Access Compliance Report

Public Rights-of-Way

(Curb Ramps)

Intersection ID: 29681	Main Street: DARLINGTON_RD	Cross Street: EQUESTRIAN_DR	Location: W
ADA ID: F2E3998BD8BB	Ramp Type: PerpDiag	Initial Pass/Fail: Fail	Overall Compliance: No
Severity Score: 22.5			
Codes/Mitigation Info/Possible Solution		Field Measurements/Component Compliance

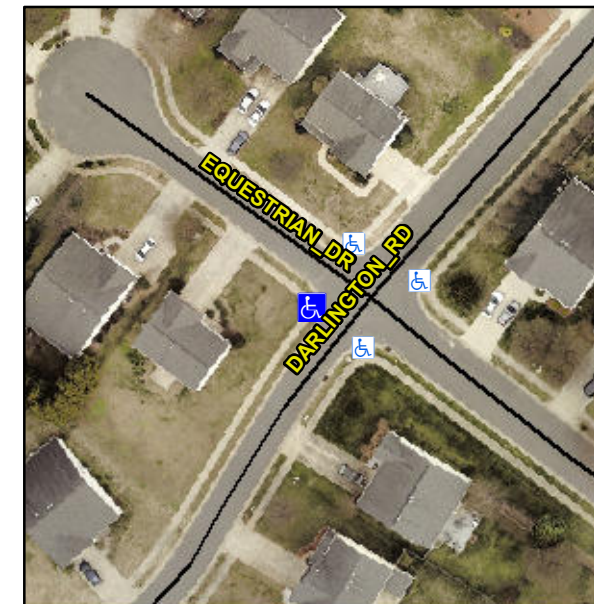
Not Found, R304.5.1, R304.2.2, R304.5.3

Compliance	Description	Data	Compliance	Description	Data
N/A	Ramp Length (in)	46.5	No	Ramp Slope (%)	11.0
No	Ramp Width (in)	37.0	No	Ramp XSlope (%)	3.7
N/A	Flare Type LT	N/A	N/A	Flare Type RT	N/A
N/A	Flare Slope LT (%)	N/A	N/A	Flare Slope RT (%)	N/A
N/A	Flare Traversable LT?	N/A	N/A	Flare Traversable RT?	N/A
N/A	Landing Length (in)	N/A	N/A	DWS Provided?	N/A
N/A	Landing Width (in)	N/A	N/A	DWS Contrast?	N/A
N/A	Landing Slope (%)	N/A	N/A	DWS Length (in)	N/A
N/A	Landing X Slope (%)	N/A	N/A	DWS Full Width?	N/A
N/A	Landing Curb? (Y/N)	N/A	N/A	DWS Offset (in)	N/A
N/A	Shared Landing?	N/A			
N/A	Gutter Ponding?	N/A	N/A	Gutter Slope (%)	N/A
N/A	Gutter Lip Ht (in)	N/A	N/A	Gutter X Slope (%)	N/A
N/A	Painted X Walk1?	No	N/A	Painted X Walk2?	No
	X Walk 1 Direction	To SE		X Walk 2 Direction	To NE
N/A	X Walk 1 Width (in)	N/A	N/A	X Walk 2 Width (in)	N/A
	X Walk 1 Slope (%)	3.1		X Walk 2 Slope (%)	2.3
	X Walk 1 X Slope (%)	2.5		X Walk 2 X Slope (%)	2.8

Remove & Replace Curb Ramp With Two New Directional Ramps or Equivalent.
